Central Planning Authority

Agenda for a meeting of the Central Planning Authority to be held on **23 October 2024 at 10:00am** in Conference Room 1038, 1st Floor, Government Administration Building, 133 Elgin Avenue

CPA/27/24

Figure 1: Aerial imagery showing the application site outlined in yellow (Source: UKHO, 2021)

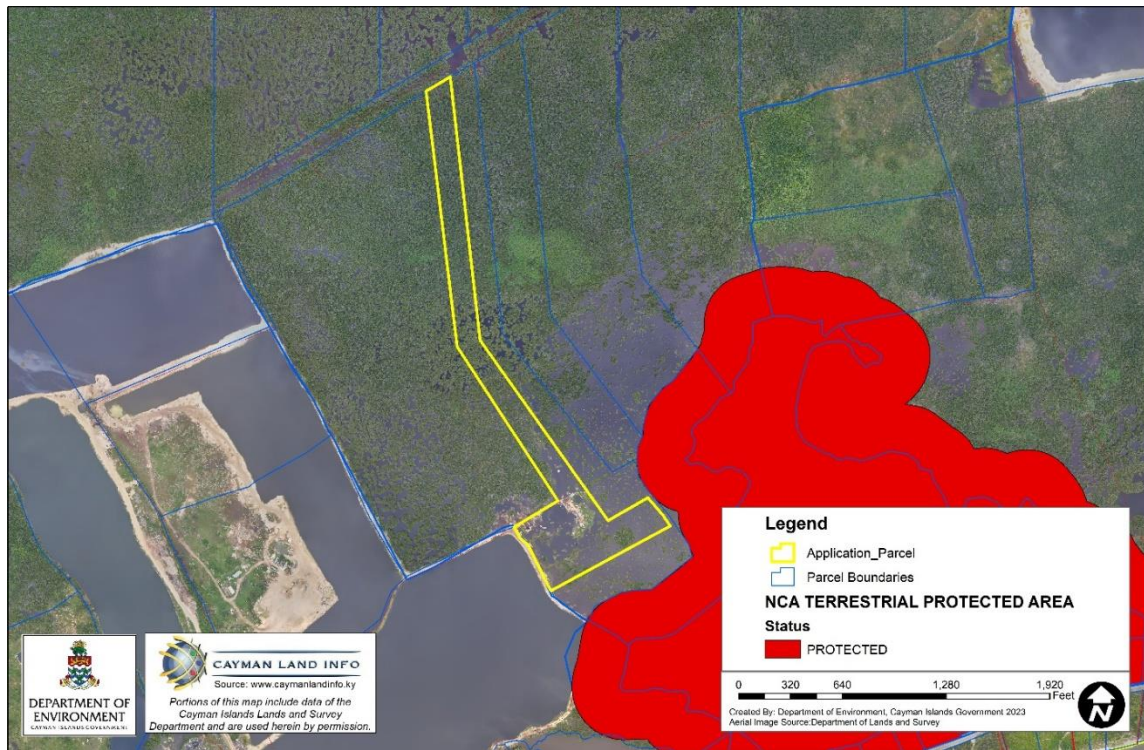
The application site consist of primary seasonally flooded mangrove habitat and is part of a wider mangrove wetland system which includes the Meagre Bay Pond Protected Area (see Figure 1) and extends into the Central Mangrove Wetland.

After we received the planning application for review, it appeared from Google Maps that part of the site had been cleared and filled. We used our drone to capture imagery of the site and found that the site was being landfilled with waste material including derelict vehicles and construction waste (see Figure 2). During our investigation, we noted that there were multiple potential infractions occurring that fell into the remit of other government agencies such as Planning Department, Water Authority, Department of Environmental Health, and Department of Agriculture. The DoE met with these agencies and visited the site. Afterwards, it was concluded that each agency would issue compliance/enforcement and abatements notices accordingly.

Our understanding from our investigation is that the purpose of this subdivision is to sell the resultant lots, which may complicate each agency's case and may allow the current landowner to divest responsibility for clean-up. It is also our understanding that the Central Planning Authority gave approval to issue a Maintenance of Land Notice. It is strongly recommended that the application is deferred until all of the agencies have completed their enforcement cases. The current landowner should be responsible for and undertake clean-up of the site prior to approving the subdivision.

Figure 3. The application site with the proposed subdivision site highlighted in blue in proximity to the Colliers Reverse shown in striped red (UKHO, 2021).

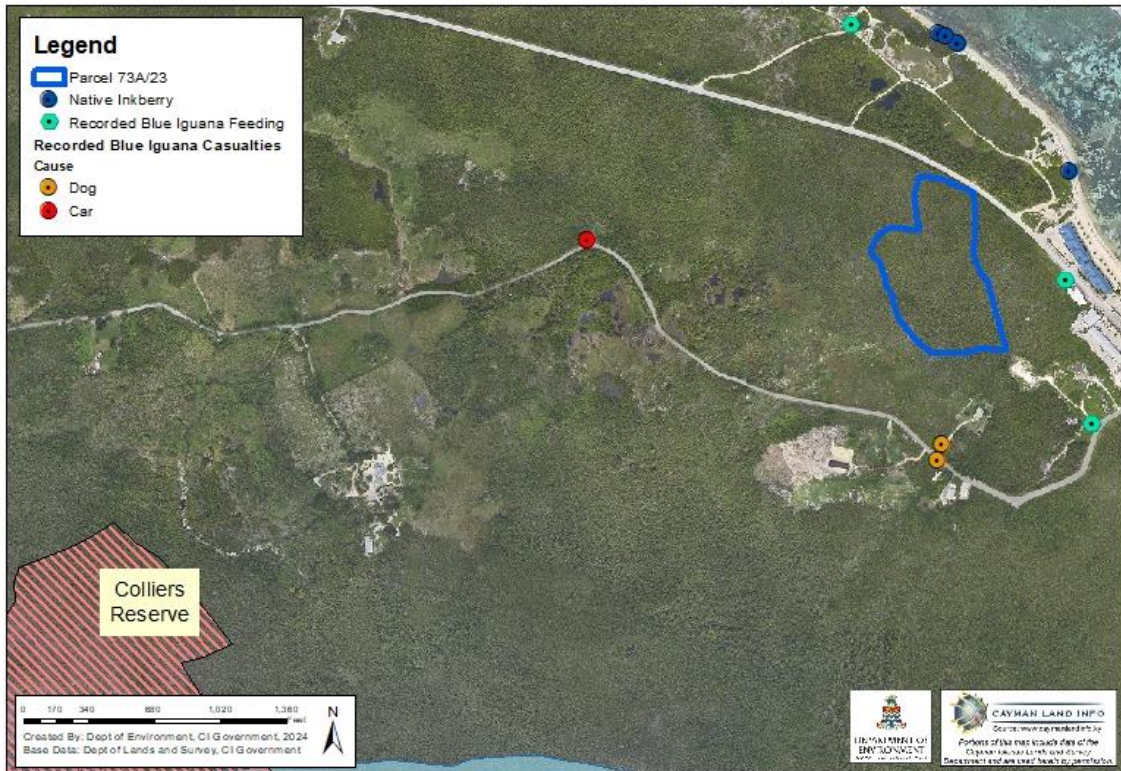
The Grand Cayman Blue Iguana (Cyclura lewisi) is a large herbivorous reptile unique to the Cayman Islands, found only on Grand Cayman, and listed as a Part 1 of Schedule 1 Protected Species in the National Conservation Act meaning they are protected at all times. As seen in Figure 3 below, the application site is in proximity to the Colliers Wilderness Reserve where captive-bred endemic Blue Iguanas have been released and now naturally reside and reproduce. Blue Iguanas have an extensive dispersal range and have been recorded nesting and breeding in primary habitat outside of the Salina and Colliers Reserves. It should be noted that there have been recorded Blue Iguanas feeding in other parcels around the proposed subdivision site therefore, it is highly likely that there are Blue Iguanas present in the subdivision site as well. Blue Iguana nesting could also take place in areas where soil is present.

The Grand Cayman Blue Iguana was once on the brink of extinction but the population has been restored through captive breeding, head-starting and release into protected areas which started in 1990 and is ongoing today. Subdivisions in primary habitat such as this one pose threats to the recovering species. Firstly, the installation of road infrastructure in approved subdivisions could lead to an increase in Blue Iguana road strikes and introduce invasive species deeper into the forest. One of the primary human-associated threats to the Blue Iguana is road kills due to cars travelling faster than the iguana or the driver can react. Free-roaming cats and dogs also predate Blue Iguanas, particularly hatchlings and juvenile iguanas. Figure 3 shows a recorded Blue Iguana death due to a car (red dot) and two recorded Blue Iguana deaths caused by dogs (orange dot). In addition, the direct removal of primary habitat that could provide food and habitat to the Blue Iguana is also a threat. As they recover from the brink of extinction, reproduce, and seek to establish territory, the urbanization of valuable primary habitat continues to be a concern for the future of our wild population that relies on this habitat to forage, shelter, and nest.

Figure 2. Proposed developments on site with the parcel boundary highlighted in red (Aerial Imagery Source: UKHO, 2021).

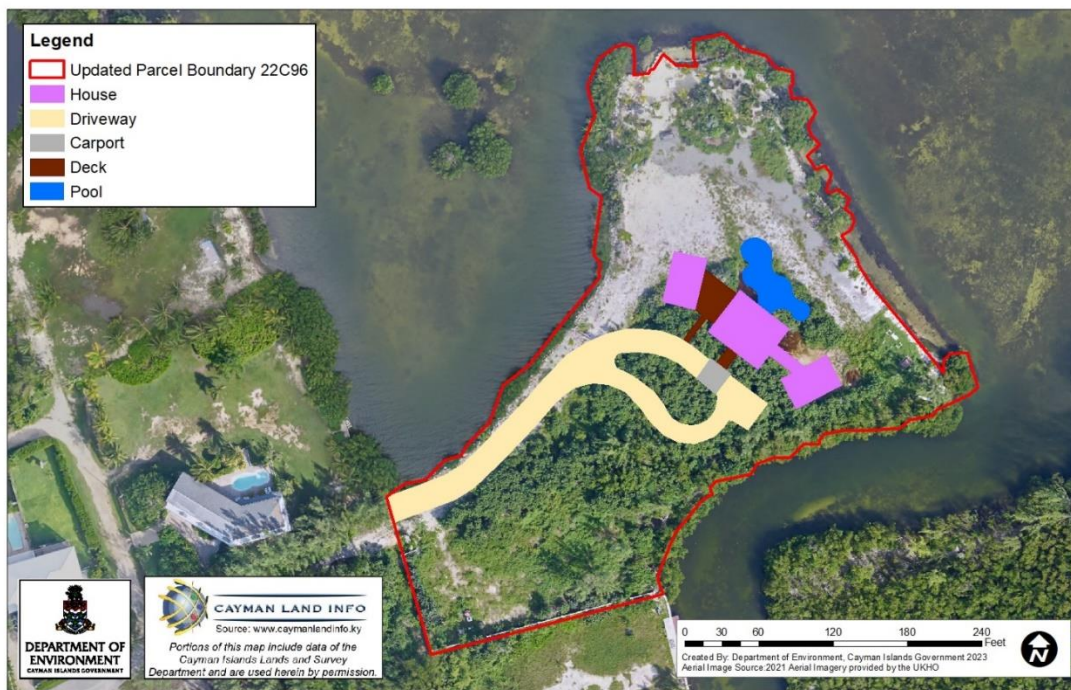
As shown in Figure 2 below, we note that the setback of the proposed development falls short of the minimum required setbacks from the registered Mean High Water Mark (MHWM) under section 8(10)(b) of the Development and Planning Regulations (2022 Revision). We note that the proposed pool is as close as approximately 51 feet from the MHWM and the proposed house is as close as approximately 54 feet from the MHWM. Although the submitted plans indicate that the site has a 50-foot coastal setback, which is used for ironshore coastlines, it does not contain the elevated ironshore features that are more resilient against erosion and sea level rise. The site has a mangrove coastline and should adhere to the minimum 75-foot coastal setback for mangrove coastlines required in the Development & Planning Regulations. The Department strongly maintains its stance that coastal setbacks should not be reduced but instead should be treated as a minimum (as prescribed in the Development & Planning Regulations). Setbacks seek to reduce the impacts of storm-related damage upon coastal infrastructure.

Figure 1. Land cover at the application site showing the proposed expansion site consists of tidally flooded mangrove forest and woodlands (Source: DoE, 2018).

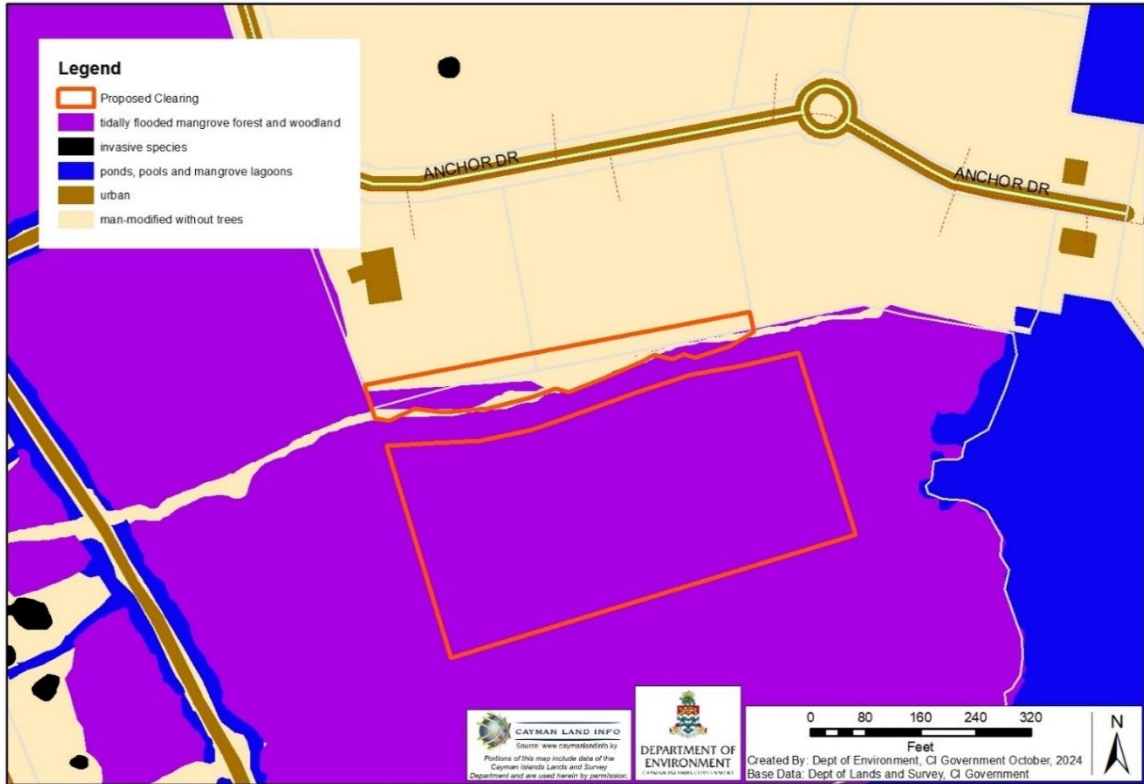
The DoE notes that the site of the proposed expansion consists of tidally flooded mangrove forest and woodland (refer to Figures 1 and 2). The applicant is reminded that mangroves are Schedule 1, Part 2 Protected Species under the National Conservation Act (NCA) with an adopted Conservation Plan. It is an offence to remove mangroves unless permission is explicitly sought to remove them either through the granting and implementation of planning permission or a National Conservation Council Section 20 permit. The Mangrove Species Conservation Plan can be downloaded at the following link: <https://conservation.ky/wp-content/uploads/2021/01/Species-Conservation-Plan-for-Mangroves-FINAL.pdf>.

Figure 3: An equivalent 5 acre site to the north of the Pro Yacht site that could accommodate the proposed expansion.

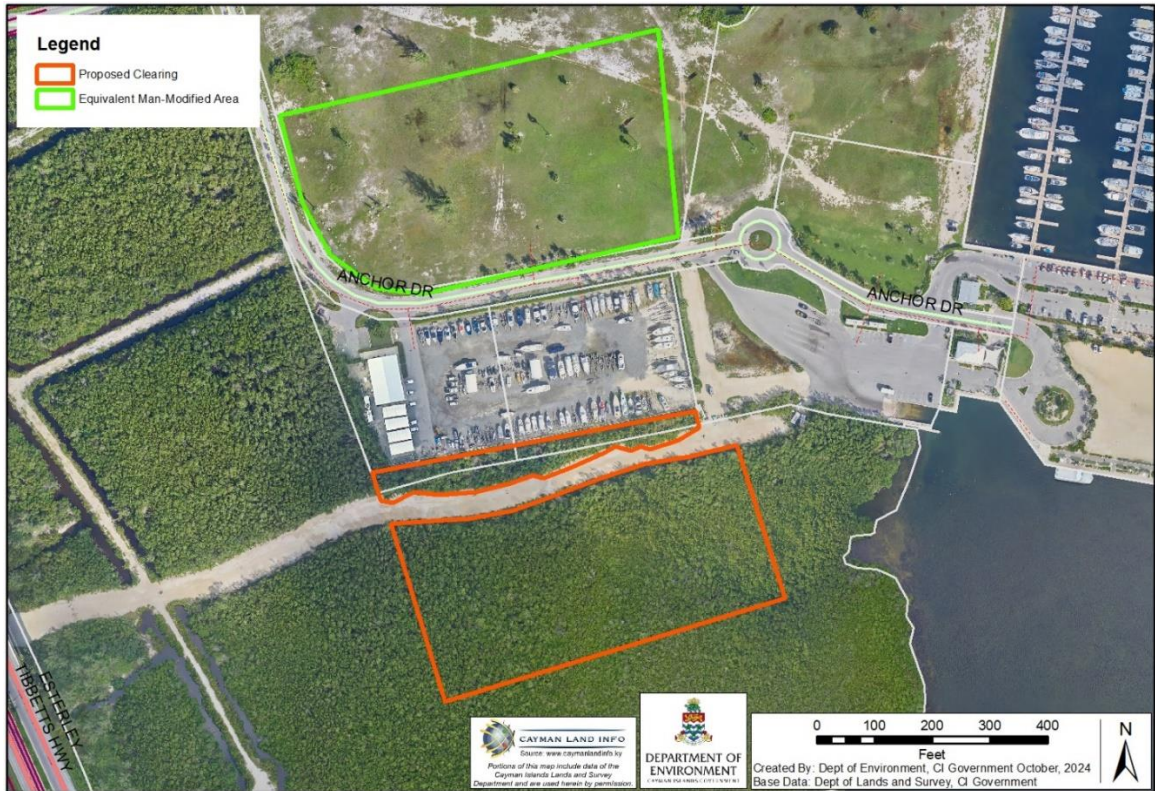
The DoE notes that the property contains a large, man-modified area, directly to the north of the existing Pro-Yacht marine site, which is currently vacant and largely devoid of vegetation and is within the same ownership as the proposed site. As shown in Figure 3, This man-modified area contains more than enough space to host the proposed 5 acre expansion without the need to remove mangroves.

As such, we highly recommend the applicant considers the relocation of the proposed expansion to use the man-modified area to the north of the Pro-Yacht site as opposed to the loss of 5 acres of mangroves and the biodiversity and ecosystem services they provide.
